Memo

Date: April 6, 2015

Subject: Design Request for the ATFII Linac Tunnel and EH1

Figure 1: Preliminary layout of ATFII with errors.

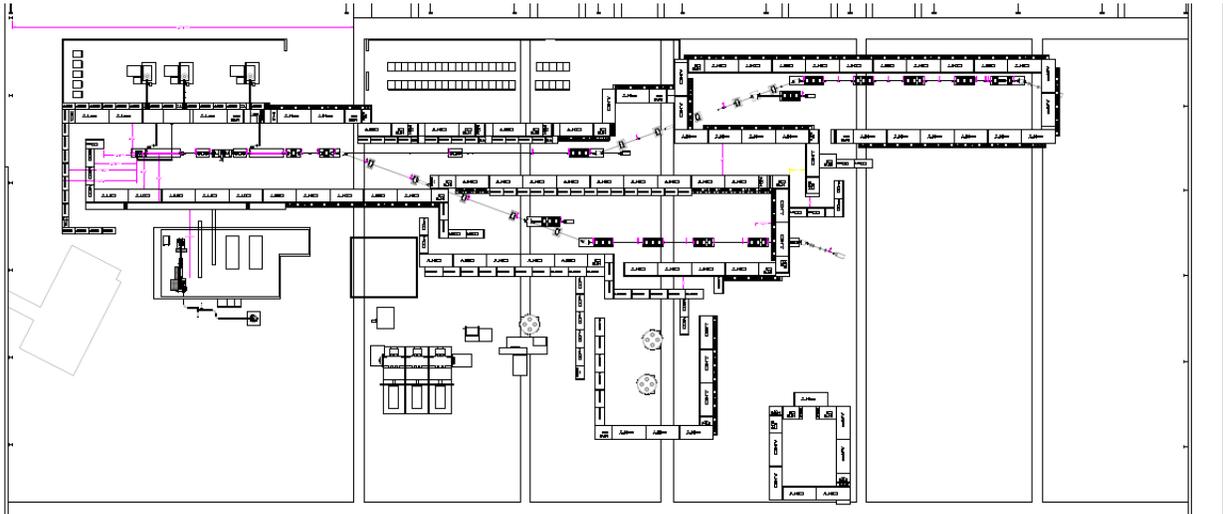
An incomplete and incorrect layout of ATFII in Building 912 is shown below to give readers some idea of what the layout may look like in the future. It should not be assumed that any of the

shielding walls, labyrinths etc. are correct. The beam layouts for the experimental beam lines was just updated a few days ago. However, construction of the walls for the upstream section of the Linac tunnel has started since the design is nearly complete. It is expected that the RSC will be asked to review the Linac tunnel to the EH1 extraction dipole in the near future. In addition, the UED will begin operations within six to eight months and a review will soon be scheduled. The design documents are presently being prepared for the RSC reviews.
